# ADA Curb Ramp New Construction Inspection Form (Perpendicular)

Nw Kaye

24952.54

NW King

## PERPENDICULAR RAMP (PR)

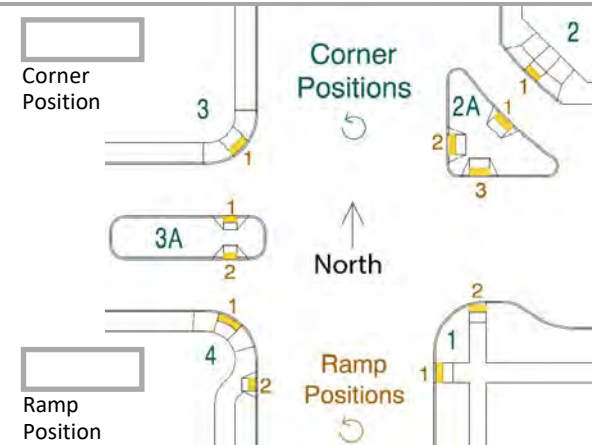
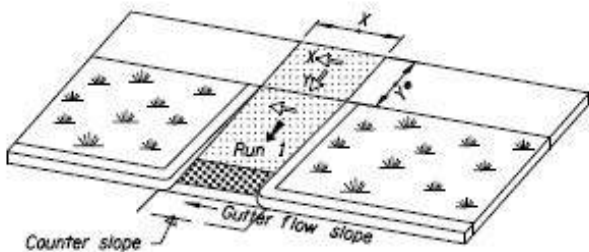
2.3

3.3

RR1 ICRR, IITD
